CONSTRUCTION PLANS  
FOR  
**SKYLINE AT LORSON RANCH FILING NO. 1**  
STREET AND STORM SEWER  
CONSTRUCTION PLANS

SF-22-001

# ENG-SF22001-R2-CDs.pdf Markup Summary

SHEET NUMBER  
C0.1  
TOTAL SHEETS: 17

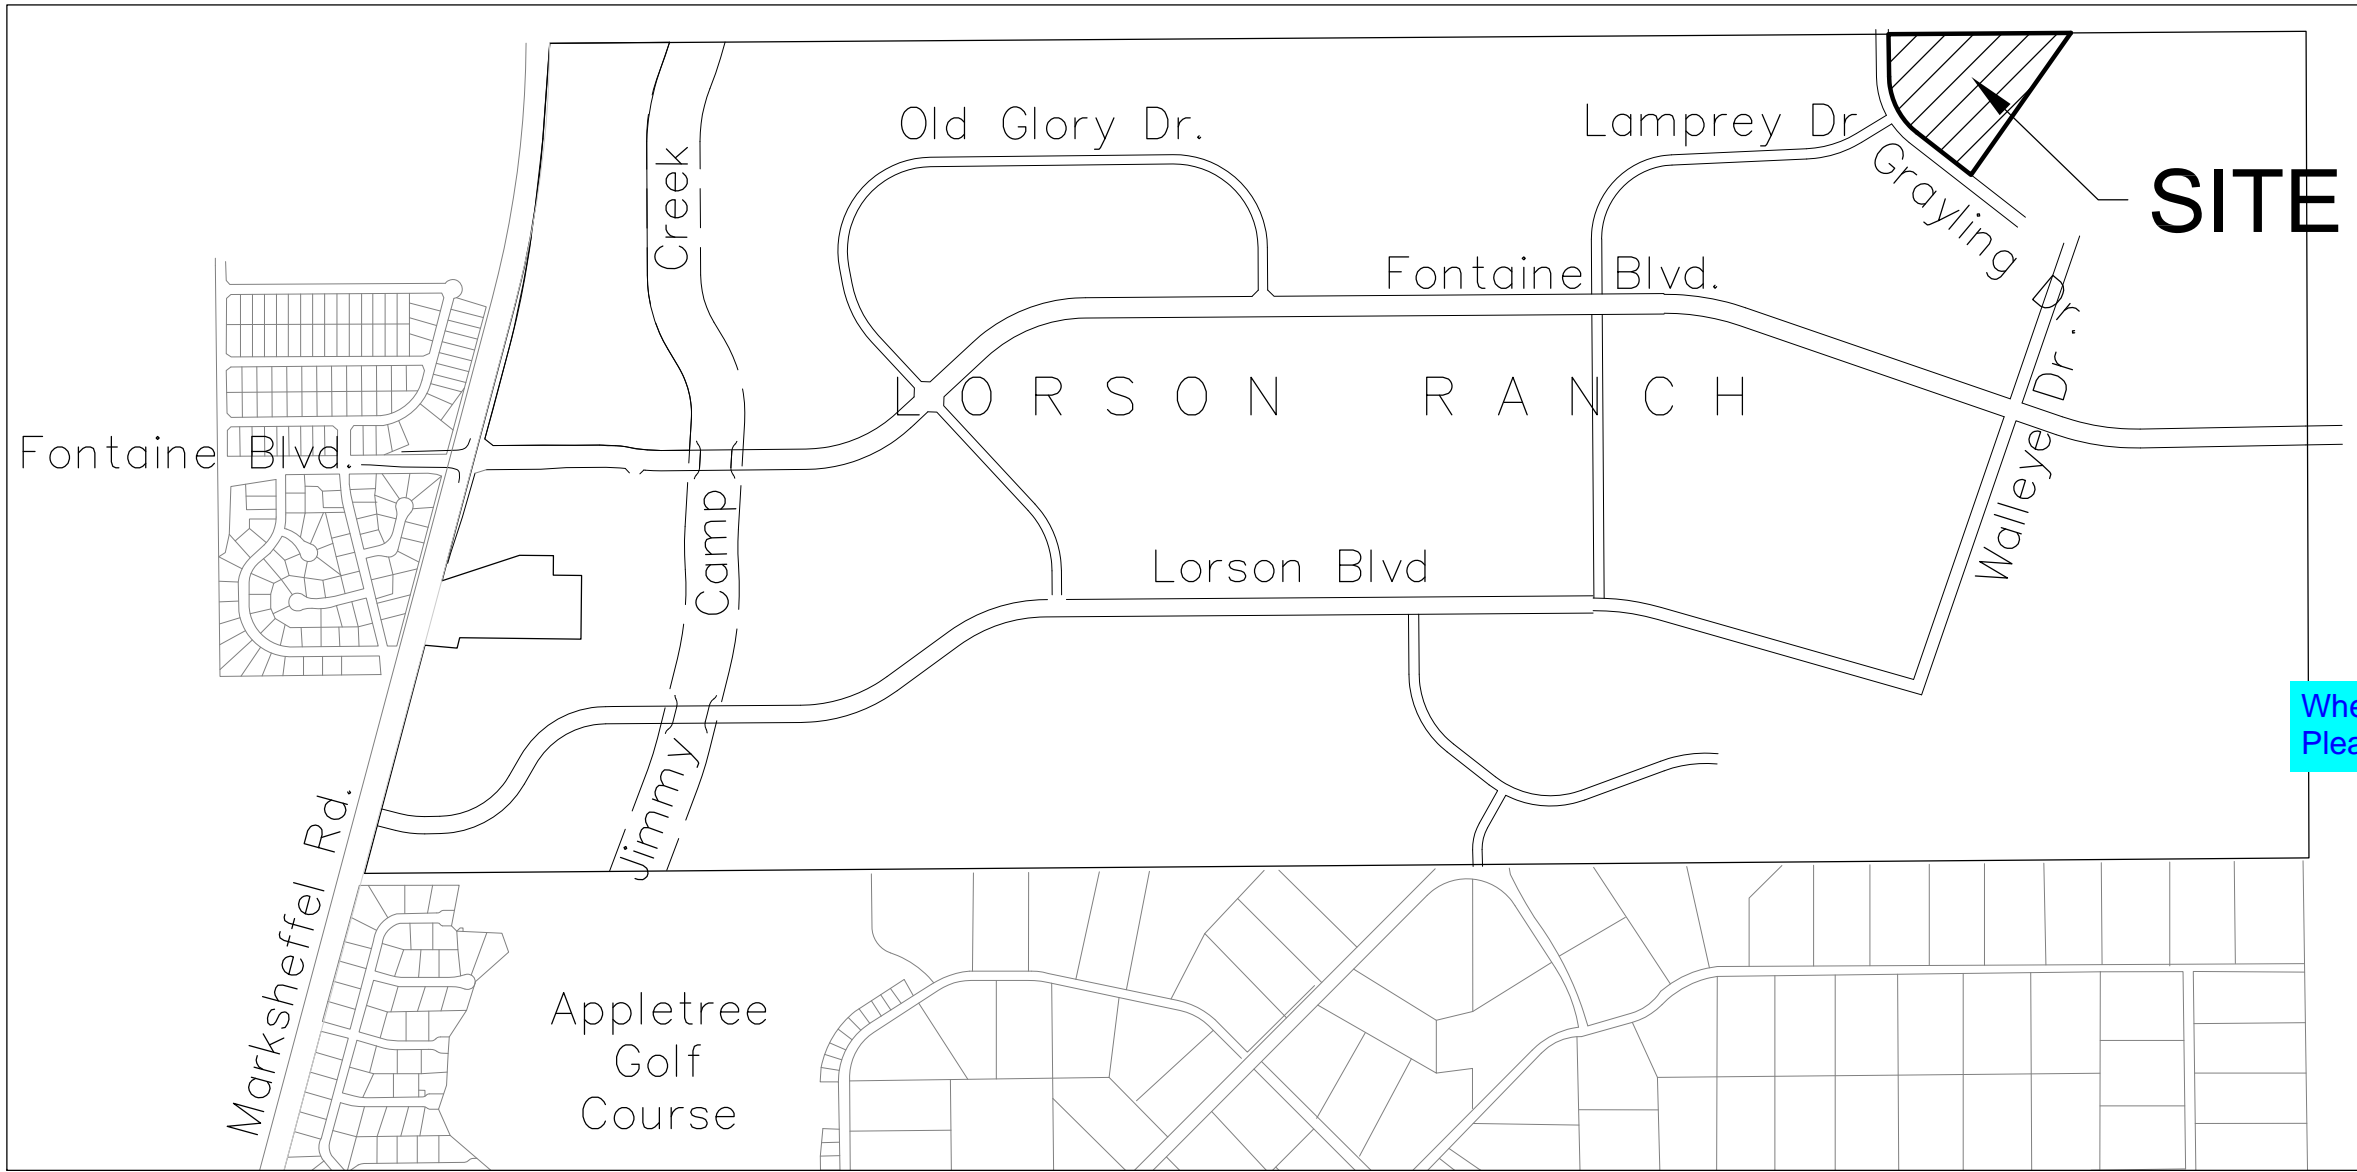
Where did sheet C9.1 go?  
Please add back to plan set.

And remember to address  
my comment on that sheet  
from Review #1 about the  
office plate.

SHEET NUMBER  
C7.2

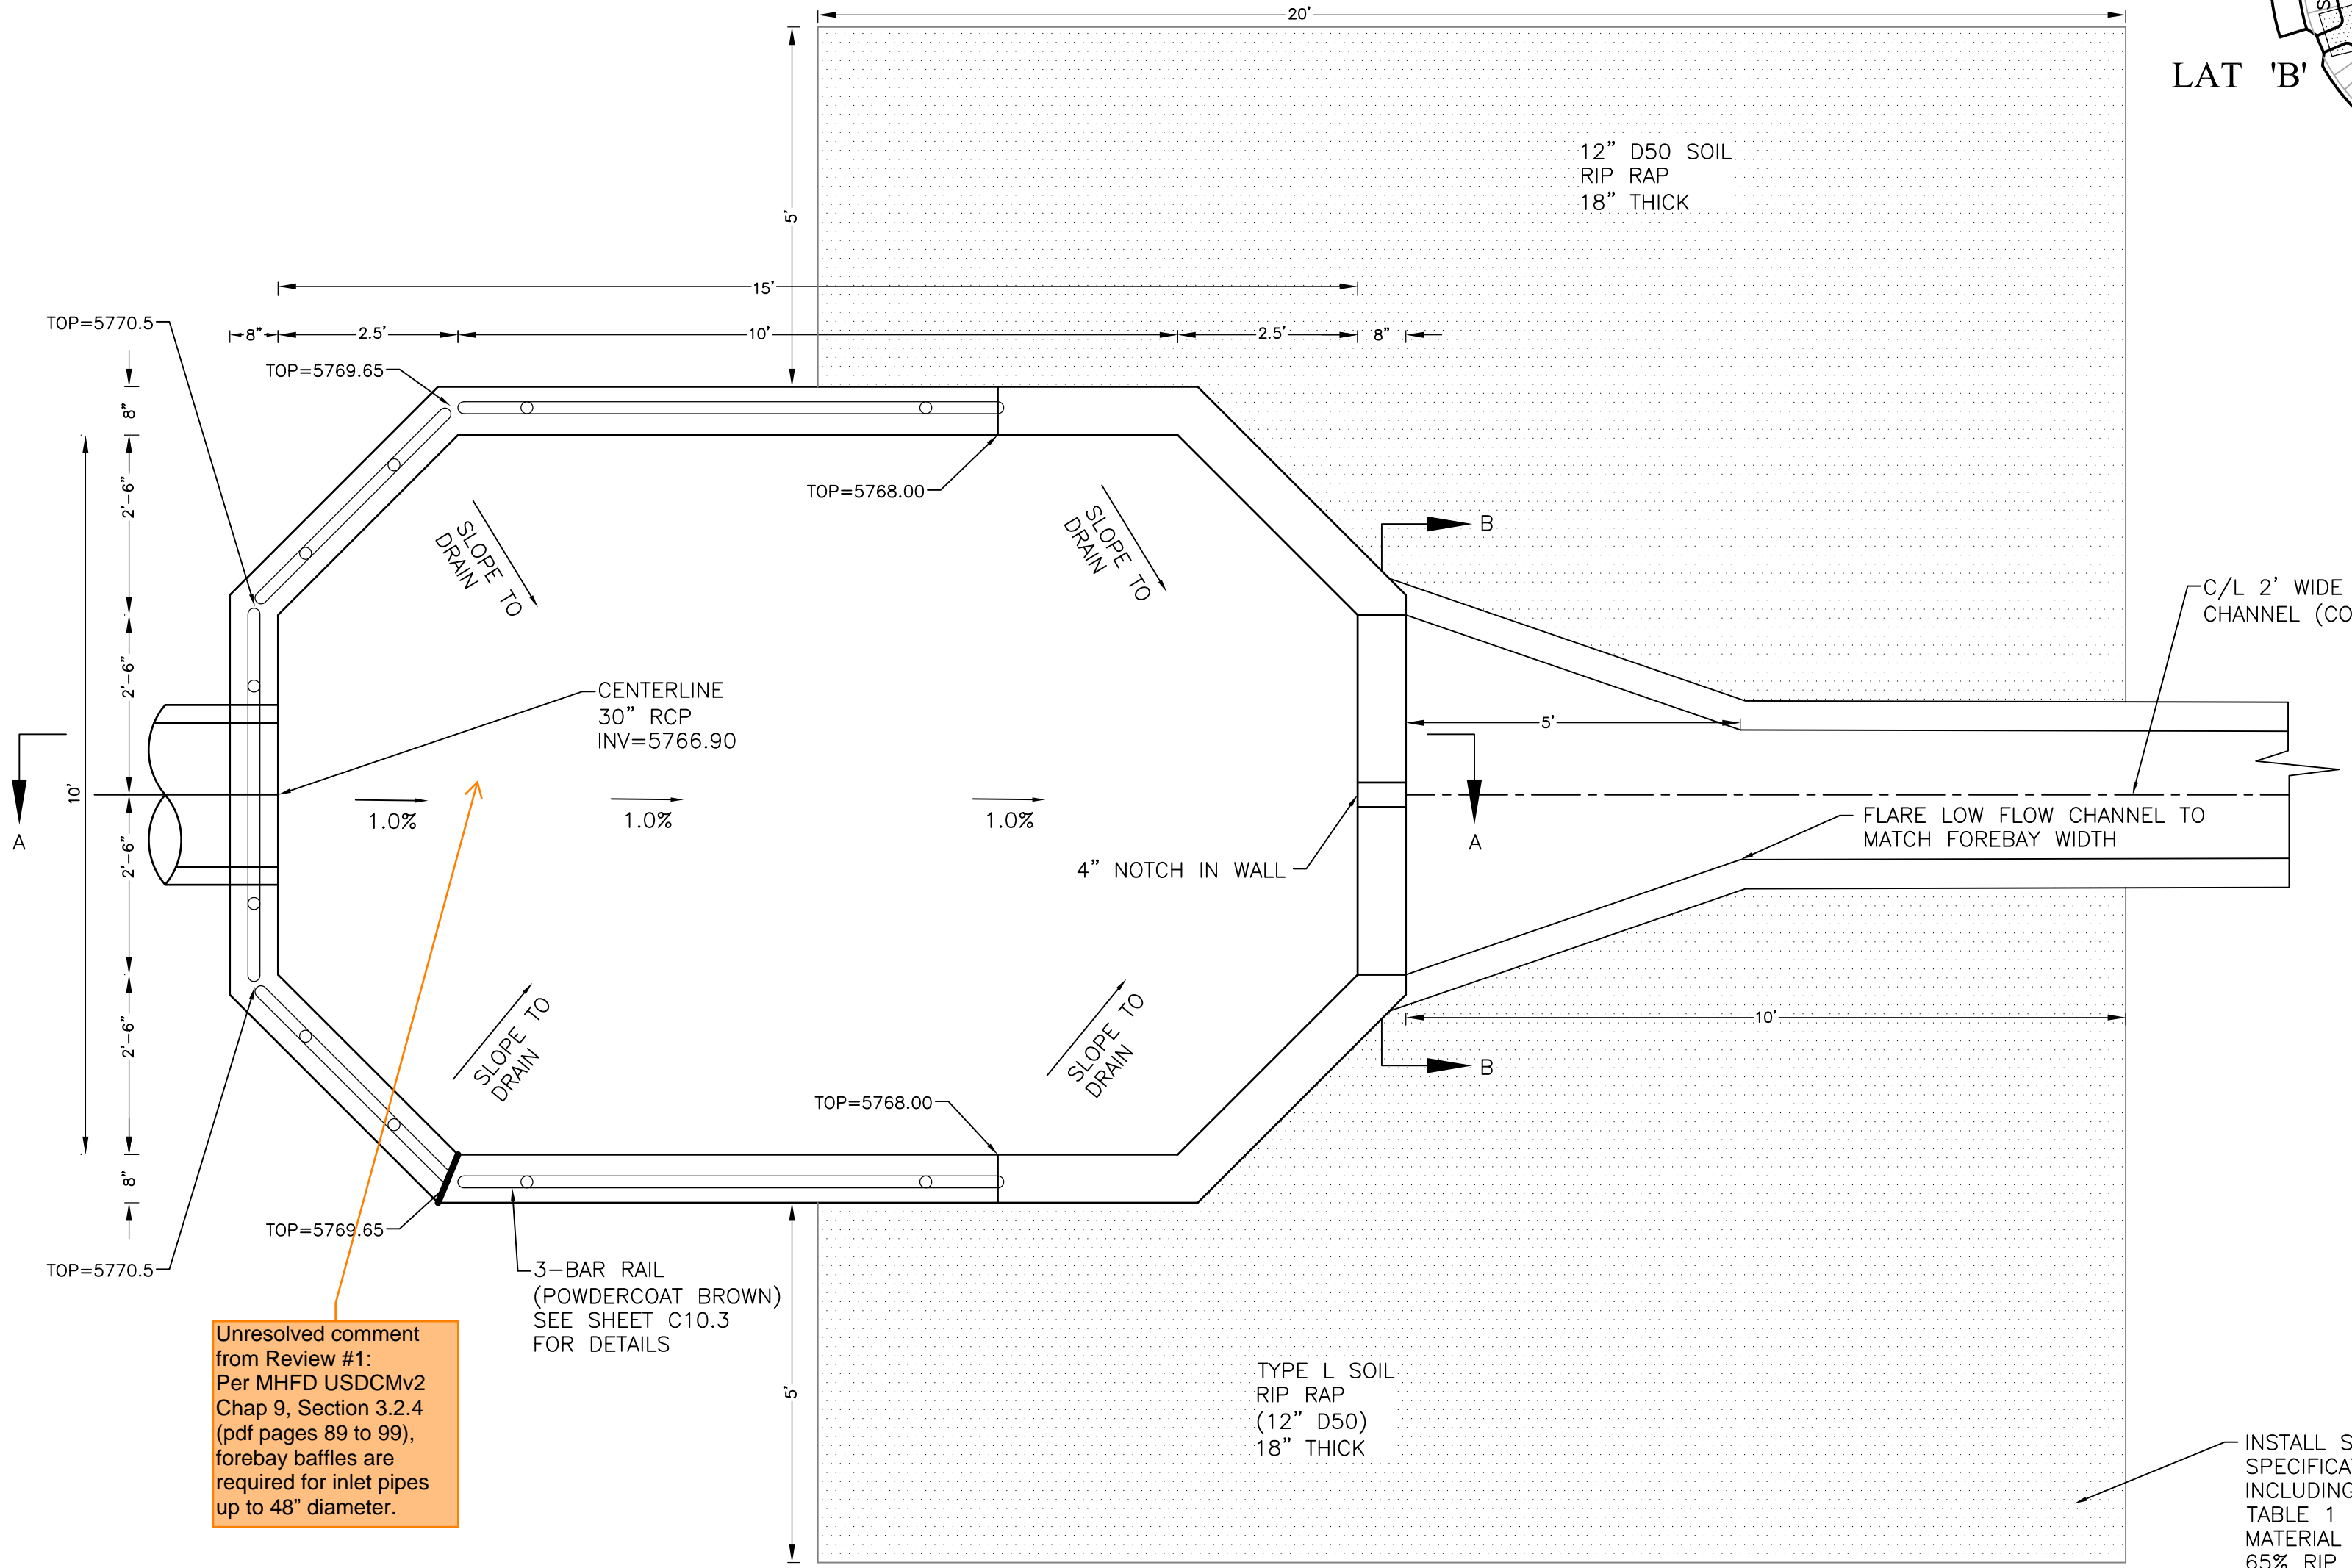
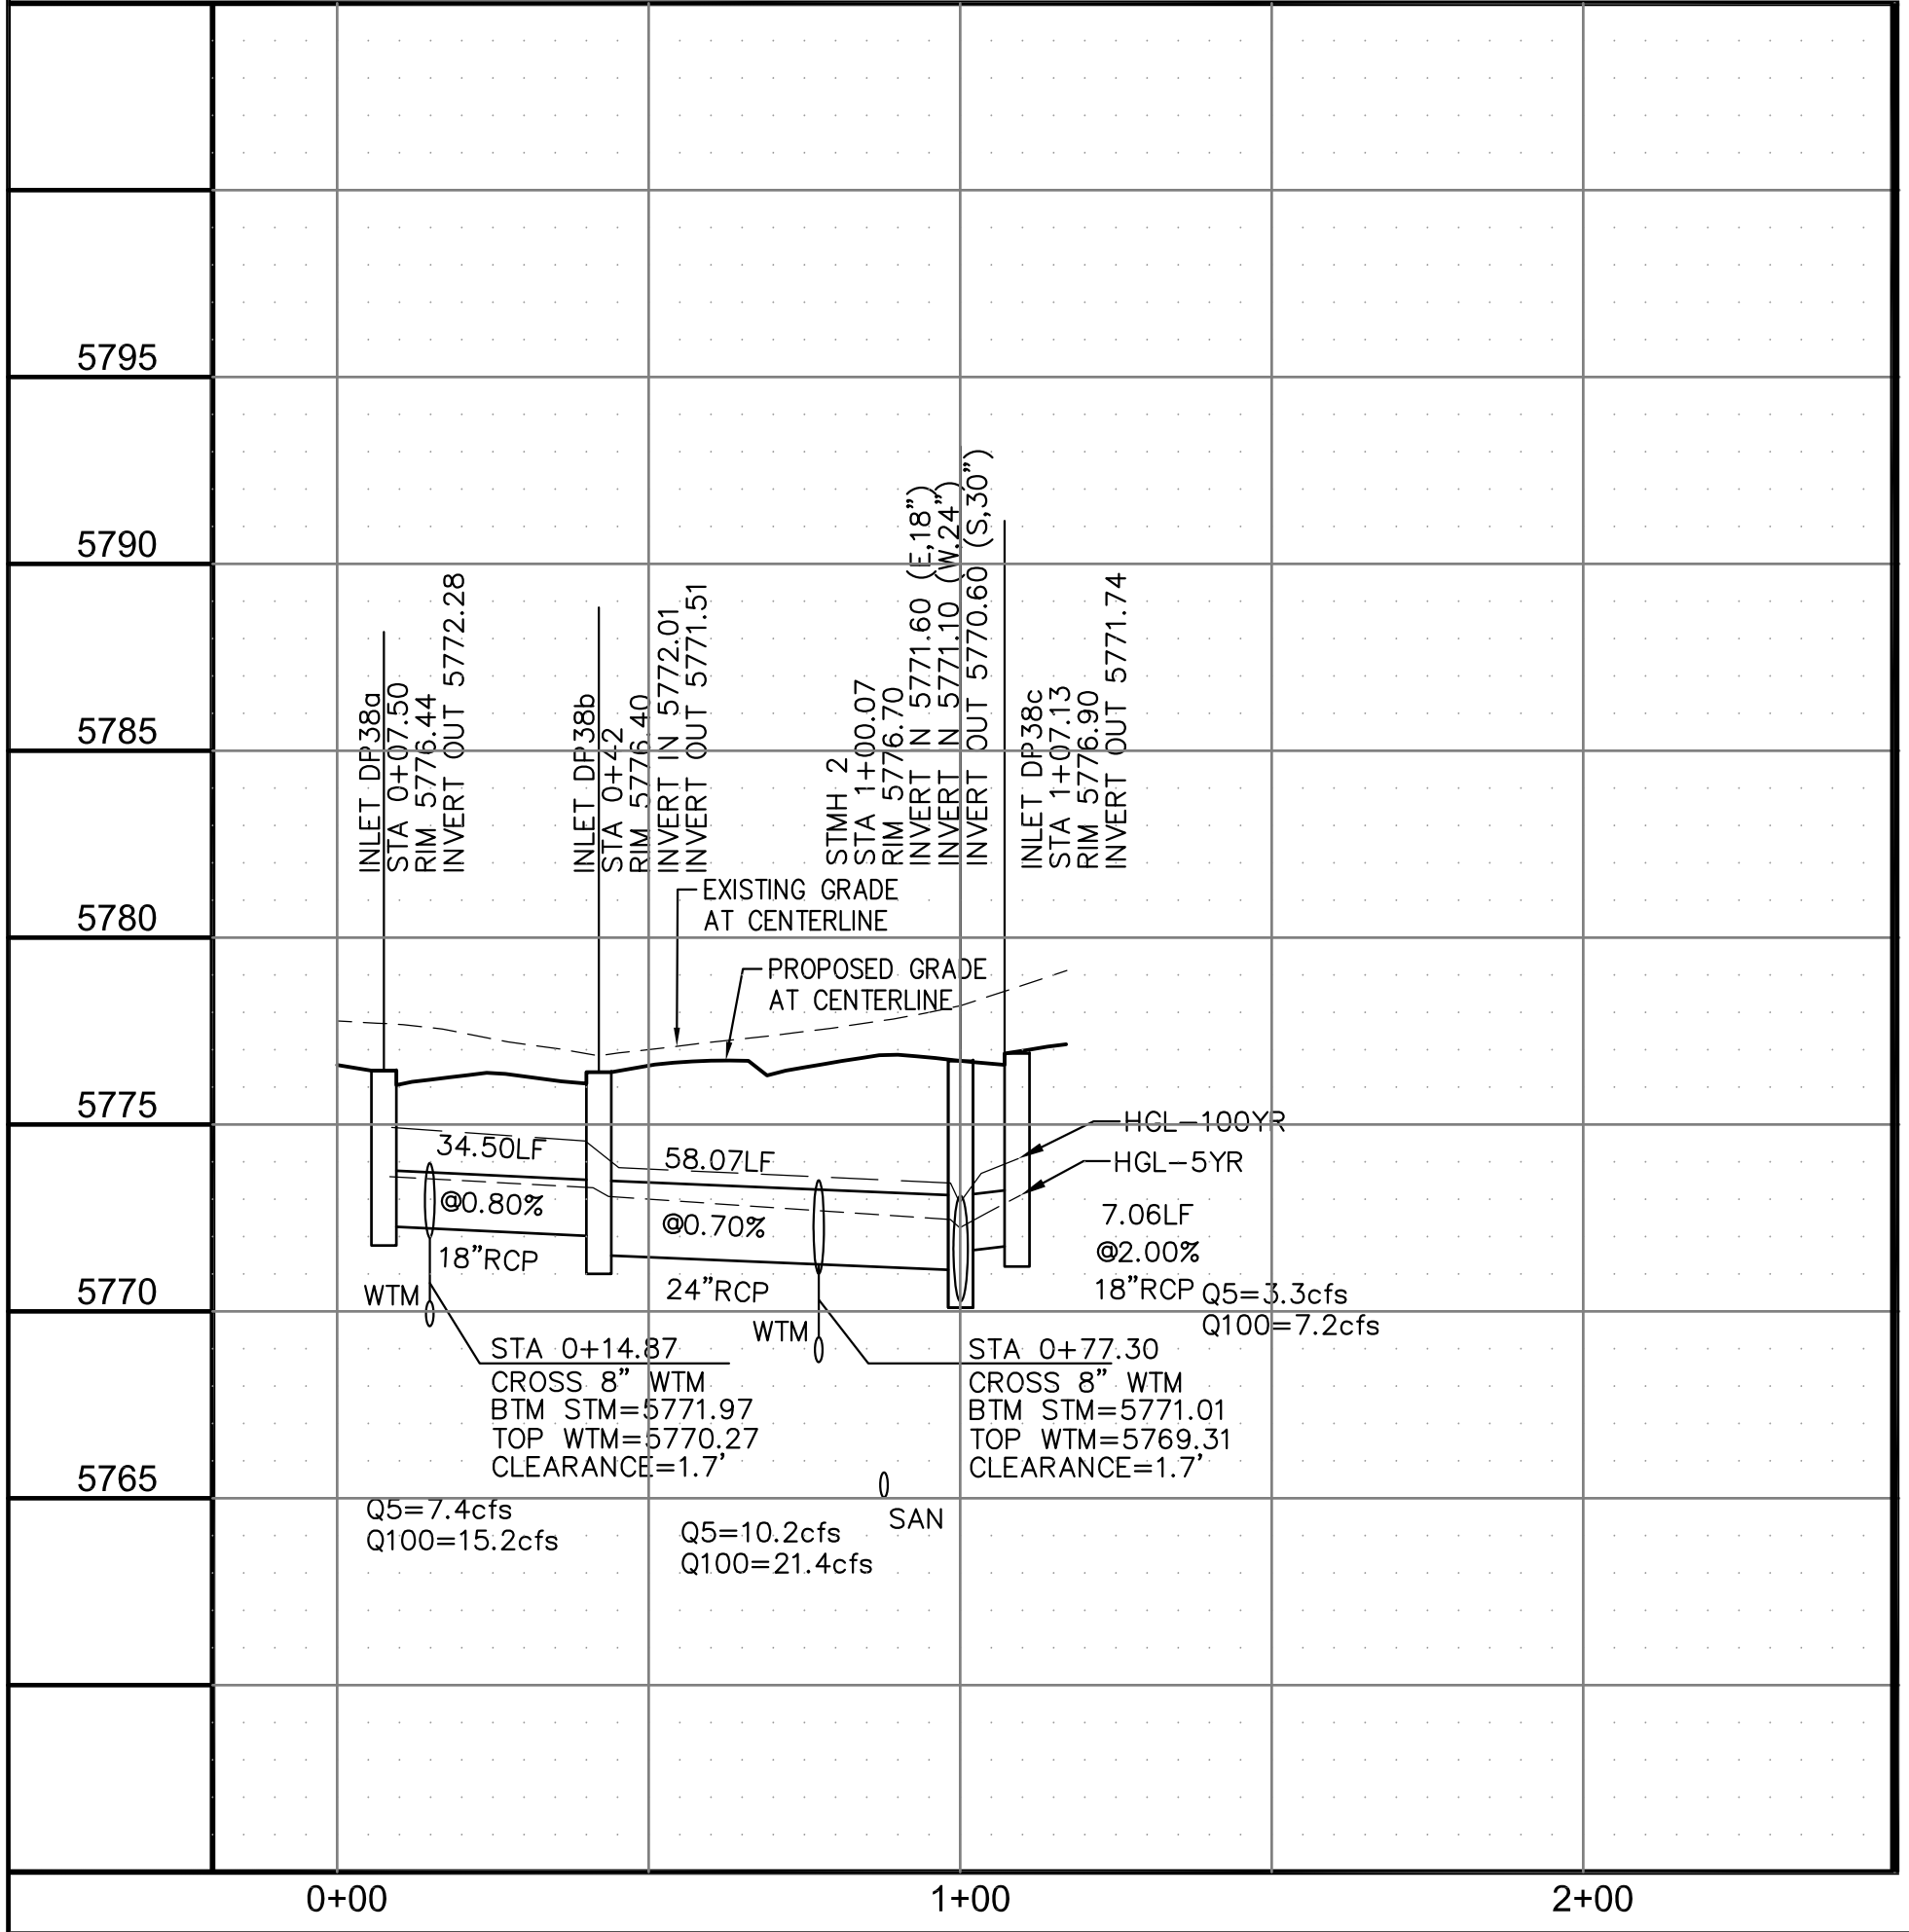
Unresolved comment from Review #1:  
Per MHFD USDCMv2 Chap 9, Section 3.2.4 (pdf  
pages 89 to 99), forebay baffles are required for  
inlet pipes up to 48" diameter.
